Access Compliance Report

Public Rights-of-Way

| Intersection ID: 29716 | Main Street: GATESVILLE_LN | Cross Street: MEDOC_MOUNTAIN_DR | Location: S |
| ADA ID: E5B3B24C179D | Ramp Type: BlendTrans1 | Initial Pass/Fail: Fail | Overall Compliance: No |

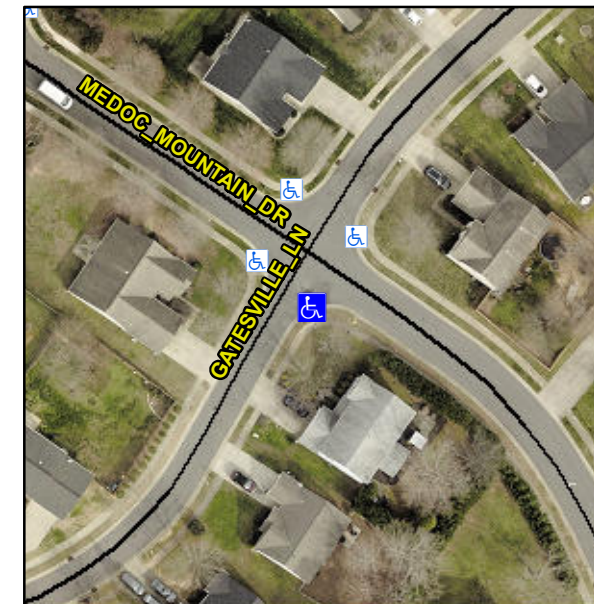
Not Found, R304.5.1, R304.5.3

| Compliance | Description | Data | Compliance | Description | Data |
|------------|-----------------------|-------|------------|-----------------------------|-------|
| No | Ramp Width (in) | 47.0 | No | BlendTrans XSlope (%) | 6.7 |

Remove & Replace Curb Ramp With Two New Directional Ramps or Equivalent.
